# TYRONE TOWNSHIP PLANNING COMMISSION REGULAR MEETING AGENDA January 9, 2024- 7:00 PM

Tyrone Party Store Site Plan Amendment

# Preliminary Site Plan Review (Use Change) for

ISSUED FOR	DATE
OWNER REVIEW	12/01/2022
PERMITS	07/18/102
DRAWN : JOK	
CHECKED , JOK	
SCALE . 3/16" = 1	7-0'
JOB NO . TE-22-1	68
SHEET TITLE .	
EXTERIOR ELEVATIONS SHEE

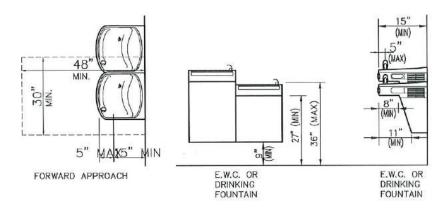
It cannot be determined whether this site plan meets all requirements as no rear or side elevations with exterior construction materials has been provided. Sheet A1.3 provides basic exterior construction materials for the front elevation but only indicates color for the asphalt shingles. All other materials are to be specified by the owner. If all proposed materials are meant to constitute a continuation of the existing façade and the proposed addition is meant to appear as part of the existing building, this section would provide an exception from Section 23.18N requirements. To determine this, Sheet A1.3 should clarify if proposed infill exterior construction materials for all elevations will match existing exterior construction materials. Side and rear elevations showing the proposed addition and specifying exterior construction materials and their location should be provided on new sheets. The specifications for framing materials to be used for the new proposed double door entry are shown on Sheet A1.2 but are missing from Sheet A1.3 and should be added so all façade materials are shown on one sheet.

If the requirements in Section 21.38F are not fulfilled, Section 23.18N provides a Schedule Regulating Facades Materials. Sheet A1.3 provides finish materials stated as ledger stone veneer, metal staggered shaker siding and asphalt shingles (canopy and roof) but does not provide percentages associated with the amount of coverage. This information will need to be added to assess if the proposed materials and amounts confirm to Group 2 of the table.

Items to be Addressed: 1.) Color specifications for all materials should be provided on Sheet A1.3 in color print. 2.) To determine if Section 23.18F requirements have been fulfilled, Sheet A1.3 should note whether proposed infill exterior construction materials for all elevations will match existing exterior construction materials. Side and rear elevations showing the proposed addition as well as specifying exterior construction materials and their location should be added to the site plan. 3.) The specifications for framing materials to be used for the new proposed double door entry should be added to Sheet A1.3 4.) the Architectural Review Committee shall review all building materials prior to site plan approval. 5.) Building material façade finishes shown on Sheet A1.3 should include percentages of coverage as well as conformance to the materials specific in Section 23.18N Group 2 if Section 23.18F is not fulfilled. 6.) Mechanical equipment location must be shown on Sheet C3.0 as well as A1.3 to ensure proper placement and screening (if necessary).

- 16. Applicant should refer to Section 27 of the zoning ordinance if/when existing signage is modified to accommodate the change in use.
- 17. Color specifications for all materials should be provided on Sheet A1.3 in color print.

- 18. To determine if Section 23.18F requirements have been fulfilled, Sheet A1.3 should note whether proposed infill exterior construction materials for all elevations will match existing exterior construction materials. Side and rear elevations showing the proposed addition as well as specifying exterior construction materials and their location should be added to the site plan.

- 19. The specifications for framing materials to be used for the new proposed double door entry should be added to Sheet A1.3
- 20. The Architectural Review Committee shall review all building materials prior to site plan approval.

- 21. Building material façade finishes shown on Sheet A1.3 should include percentages of coverage as well as conformance to the materials specific in Section 23.18N Group 2 if Section 23.18F is not fulfilled.

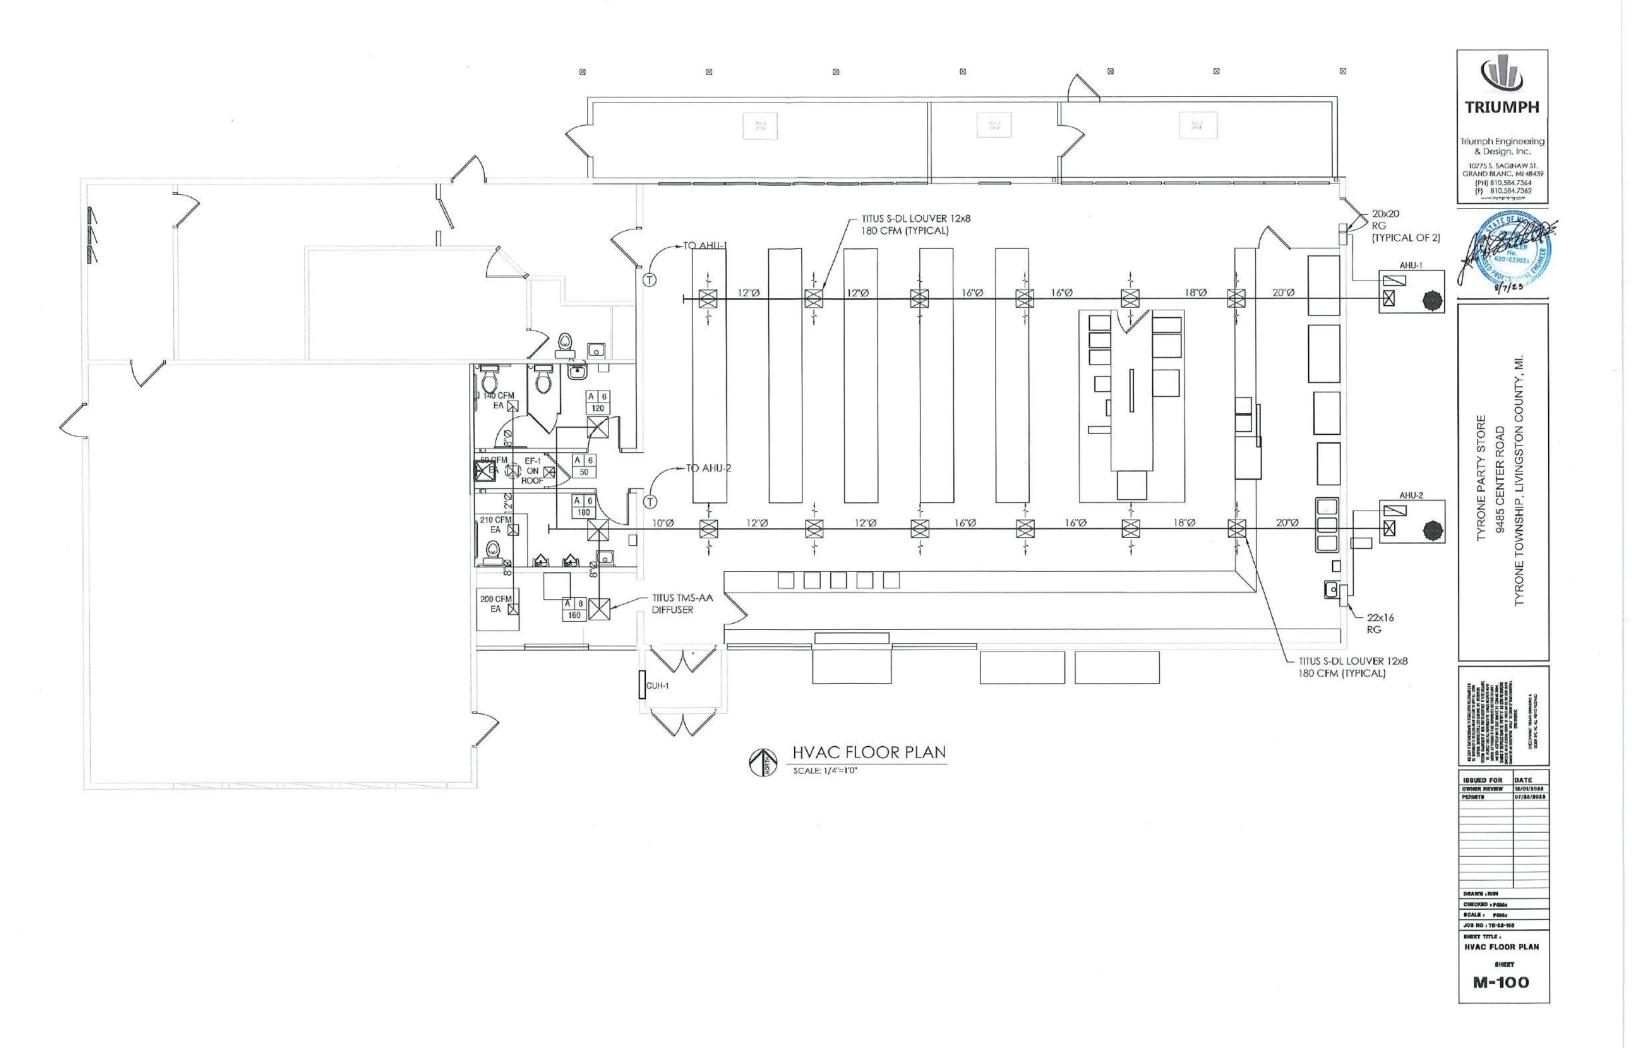
**Items to be Addressed:** Aerial photos as well Sheet C3.0 indicate site parking and storage operations exceed the eastern lot line. We recommend site operations conform to property lot lines.

**Items to be Addressed:** 1.) The existing structure encroaches the west side yard setback. Documentation either through ZBA approval or pre-existing nonconformity needs to be submitted for review. 2.) The east side yard setback measurement must be added to sheet C3.0. 3.) Building height must be measured from grade to the mid-point between the eave and ridge and added to Sheet A1.3.

Parking calculations are provided on Sheet C3.0 but use the retail store requirements for all usable square feet. However, gas stations are defined under "auto service station", in the Zoning Ordinance. If the gas station operations are to remain, the calculations above show deficiencies. These cannot be accurately calculated as no peak employment information or vehicle stacking space was provided in the application.

**Items to be Addressed**: 1.) Handicap spaces must be the correct dimensions and shown on Sheet C3.0. 2.) Parking should be calculated based on auto service station as well as retail use. 3.) One (1) loading space must be added and shown on Sheet C3.0 per Section 25.03 D and Section 25.11 4.) Pavement repair to assure safe circulation on site

The legend and color (yellow) used to show existing sewer infrastructure is blurred and difficult to identify on Sheet C2.0 and C3.0. Given the current operations, it is assumed the site has sufficient water/sewer service. However, a note should be added to Sheet C2.0 and C3.0 stating if the site is well/septic or public water/sewer. The sheet must also use colors and text that clearly identify infrastructure by name and location.

Parking lot landscaping requirements are written to refer to parking lot islands or aisleways of which the current proposal has none. Sheet C3.0 indicates some landscaping near the entrance of the existing convenience store but no dimensions or plant specifications are provided.

Sheet C3.0 shows an existing six (6) foot wood fence for the dumpster area. Gate specifications were not provided. The location of the dumpster does not comply with Section 21A.11 as the proposed location is in the side (west) yard and visible from Center Road. Given no topographic challenges, the receptacle should be relocated to the rear of the building.

Items to be Addressed: 1.) Dumpster gate specifications should be added to Sheet C3.0. 2.) The location of the dumpster should be moved to the rear of the building and shown on Sheet C3.0. 3.) Planning Commission will need to determine if existing conditions fulfill front yard landscaping requirements. 4.) Planning Commission will need to determine if it will require landscaped screening along any portion of the property perimeter. 5.) Planning Commission will need to determine if existing conditions fulfill landscaping adjacent to roads requirements. 6.) Planning Commission will need to determine if it will require information to calculate general landscaping requirements for one (1) tree per three-thousand (3,000) sqft of unpaved open surface 7.) Planning Commission will need to determine if existing landscaping adjacent to parking areas fulfill requirements.

The site plan shown on Sheet C3.0 indicates two existing light poles located at opposite ends along the southern portion of the lot directed at parking areas. The light pole closest to North Old US 23 Hwy is not on the applicant's property. Building lighting is not indicated on site plans or building elevations. No photometric information, including footcandle measurements, was included in the site plan.

Sheet C3.0 shows the location of an existing sign. However, no structural or sign dimensions are provided. Table 27.1 of the Zoning Ordinance outlines permitted and non-permitted sign allowances and regulations per zoning district. Applicant has not stated whether new convenience store will require new freestanding or building wall signage.

Two (2) Air Handling Units (AHU's) are shown on HVAC and Plumbing floor plans at the eastern end of the building. However, these units are not shown on Sheet C3.0. It should be clarified if these units are new and what their proposed location is as this equipment is typically found on rooftops. Mechanical equipment on rooftops must conform to Section 23.18C

- 1. It should be stated on the application whether the auto salvage yard operations will cease along with the auto service station.
- 2. Site parking and storage operations exceed the eastern lot line. Future site operations should conform to property lot lines.
- 3. The existing structure encroaches the west side yard setback. Documentation either through ZBA approval or pre-existing nonconformity needs to be submitted for review.
- 4. The east side yard setback measurement must be added to sheet C3.0.
- 5. Building height must be measured from grade to the mid-point between the eave and ridge and added to Sheet A1.3.
- 6. Handicap spaces must be the correct dimensions and shown on Sheet C3.0.
- 7. Parking should be calculated based on auto service station as well as retail use.
- 8. One (1) loading space must be added and shown on Sheet C3.0 per Section 25.03D and 25.10.

- 11. Existing utility infrastructure on Sheets C2.0 and C3.0 should be clearly legible and an identifiable color.
- 12. Dumpster gate specifications should be added to Sheet C3.0.

- 13. The location of the dumpster should be moved to the rear of the building and shown on Sheet C3.0.
- 14. Consider the power granted per Section 21A.09, the Planning Commission will need to determine if existing conditions fulfill front yard landscaping, landscaping screening along the property perimeter, unpaved open surface, landscaping adjacent to roads and landscaping adjacent to parking area requirements.

- 22. Mechanical equipment location must be shown on Sheet C3.0 as well as A1.3 to ensure proper placement and screening (if necessary).
